NEVADA NUCLEAR WASTE PROJECT OFFICE COMMENTS

DRAFT GENERIC TECHNICAL POSITION

"INTERPRETATION AND IDENTIFICATION OF THE DISTURBED
ZONE IN THE HIGH LEVEL WASTE RULE (10 CFR 60)."

JUNE 20, 1986

FIGURE 1

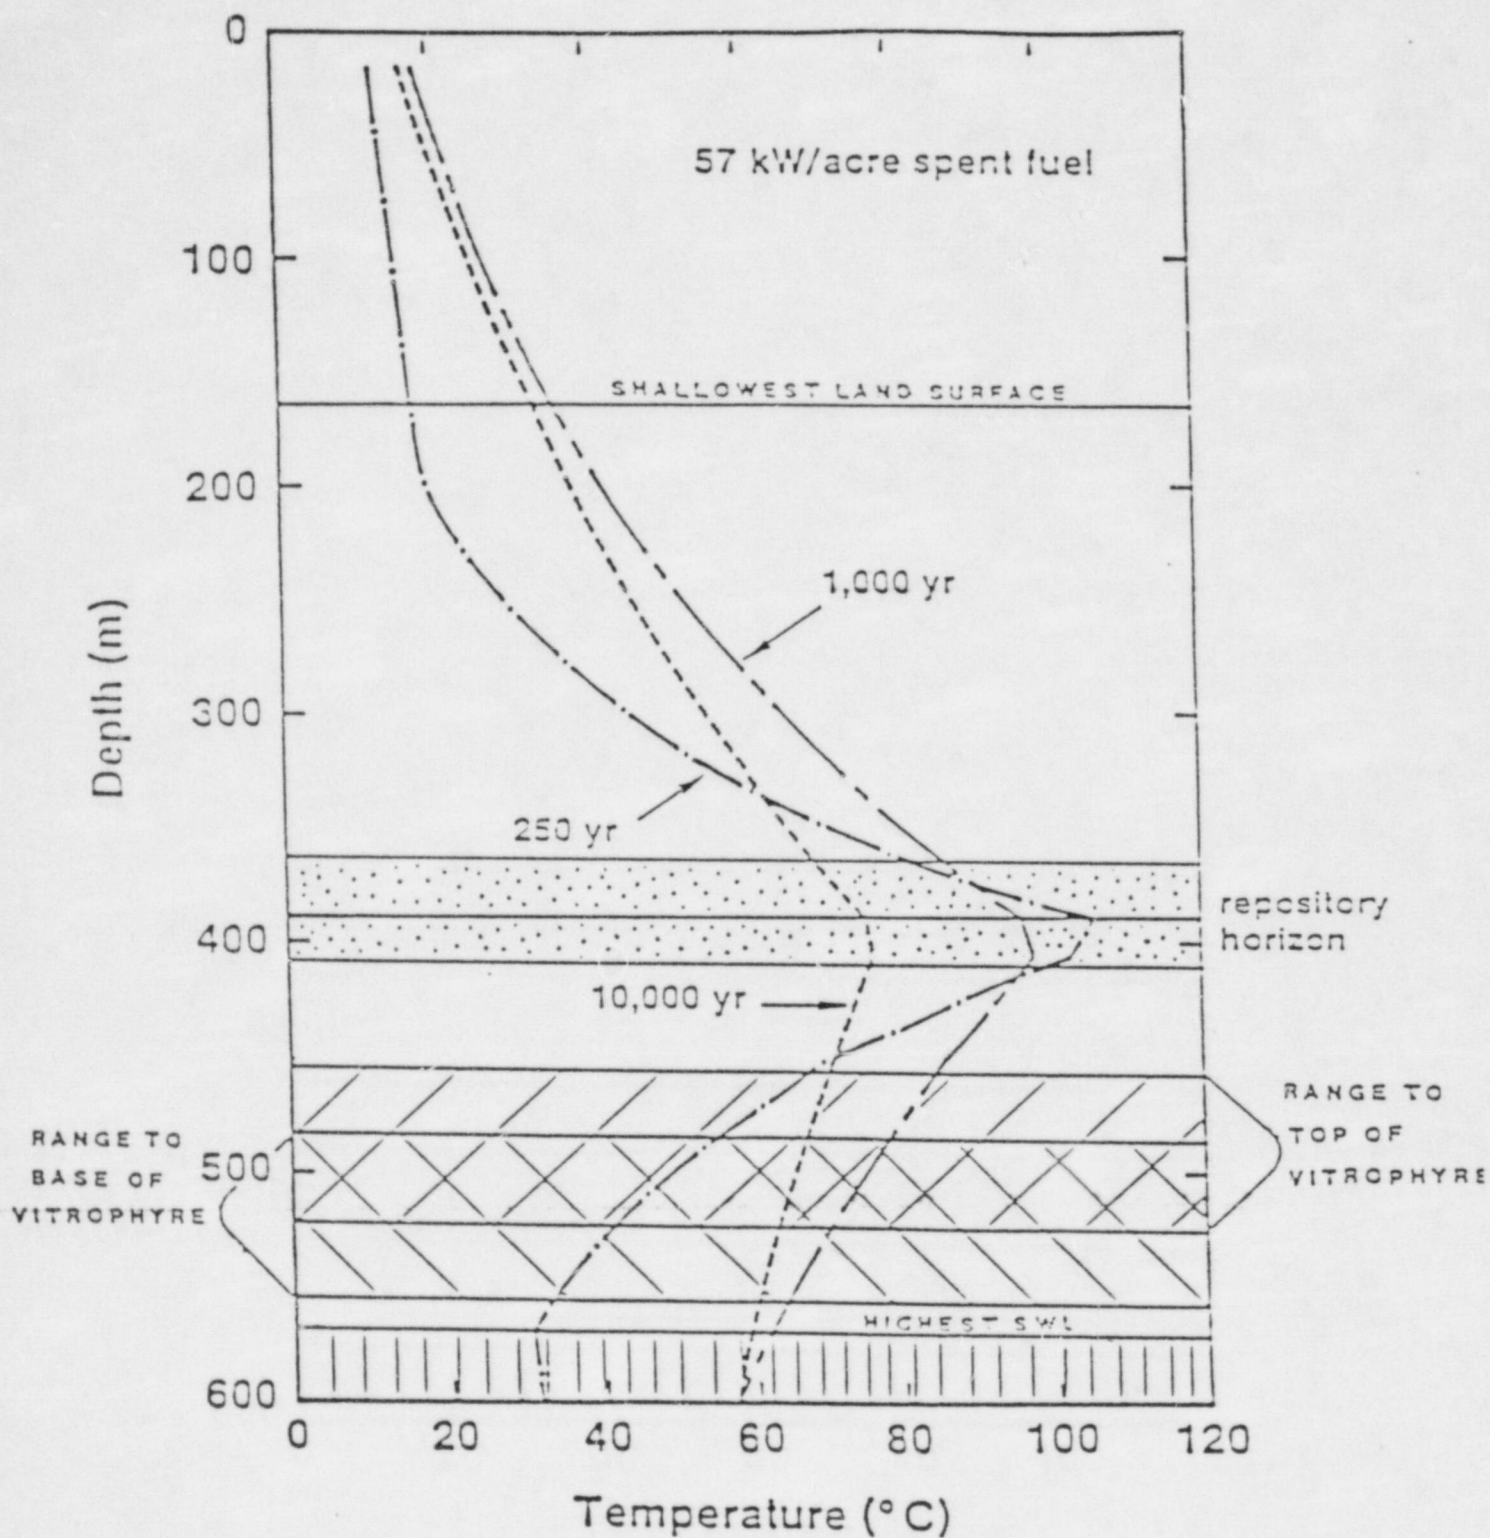
Before the DGTP definition of the "disturbed zone" can be applied to the Yucca Mountain site, the thermal history envelopes for the site need to be accurately established. Figure 1 is a site specific thermal envelope model developed for Yucca Mountain for 14.2 W/m² spent fuel (SF) with a repository midplane at 390 m (Braaithwaite and Nimick, 1984, page 10). * Commercial high-level waste (CHLW) not considered in this example, would produce higher peak temperatures in a shorter time frame give identical initial thermal loadings. Based on the EA (DOE, 1986) the average depth to the repository horizon will likely be between 250 and 300 m below land surface (see Figure 6-19, EA Pg 6-248).

We have added to Figure 1 (which depicts the maximum overburden scenario) the position of the repository zone and the range in position of the basal vitrophyre of the Topopah Spring Member. Also, the relative ranges in position of the landsurface and the water table with respect to the repository horizon have been indicated. It is important to note that the figure at best represents uncertain approximations in terms of accurately determined envelopes and relative positions of the important features such as land surface, water table, and basal vitrophyre. The thermal envelopes neglect the effects of convective transport of heat via vapor and water transport in fractures, as well as the more complex issue of possible heat sinks and sources triggered by endothermic and exothermic mineral alteration reactions that may occur due to the thermal envelope and migrating steam and hot water. We emphasize that no site-specific, referencable predictions of convective heat flow are available for Yucca Mountain; a highly preliminary study by Lawrence Berkeley Laboratory (LBL) is being reviewed by Sandia National Laboratory (SNL) at the time of this writing (September, 1986), and is not available for external review or comment.

Our objective in presenting Figure 1 is to lend perspective to the problem of establishing the boundary of the disturbed zone as proposed by the DGTP definition. We anticipate at least 30° C rise in temperature down to the water table in some areas, and major impact on the basal vitrophyre, with temperatures up to 80° C or more. In some areas, it seems likely that 40 to 50° C temperatures will occur at or near land surface if convective heat transport occurs and CHLW constitutes a supplementary waste form.
